Amendments to the Drawings

Appendix A

FIG. 1

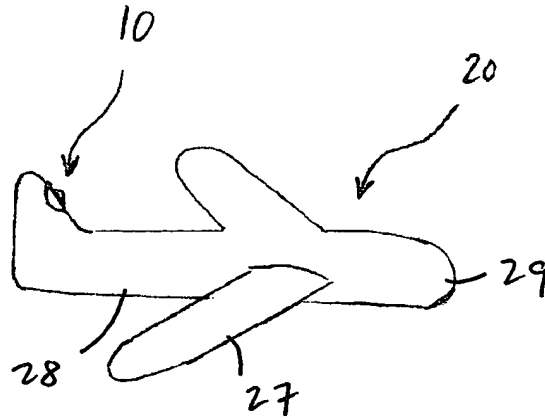
Please amend FIG. 1 of the drawings by adding reference numerals 27, 28, and 29 as clearly shown on the first replacement sheet of Appendix A. The additions of these three reference numerals accords the specification at page 3, lines 23 and 24.

FIG. 4b

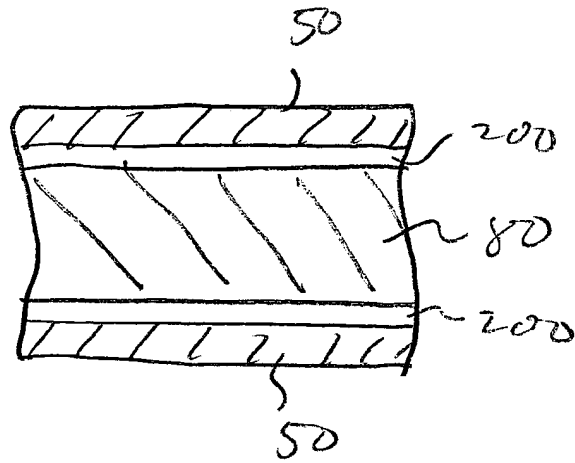
Please add new FIG. 4b to the drawings as shown on the second replacement sheet of Appendix A. New FIG. 4b has been added because it would have been difficult to indicate space 200 by adding a reference number to FIG. 4 as filed, because in FIG. 4 as filed, the space is filled with filler 210; therefore, a new reference numeral in FIG. 4 would have indicated essentially the same element as filler 210. Therefore, the addition of new FIG. 4b was deemed necessary to clearly illustrate the space between the camera and the receptacle. It is respectfully submitted that no new matter has been added to the application by the addition of FIG. 4b.
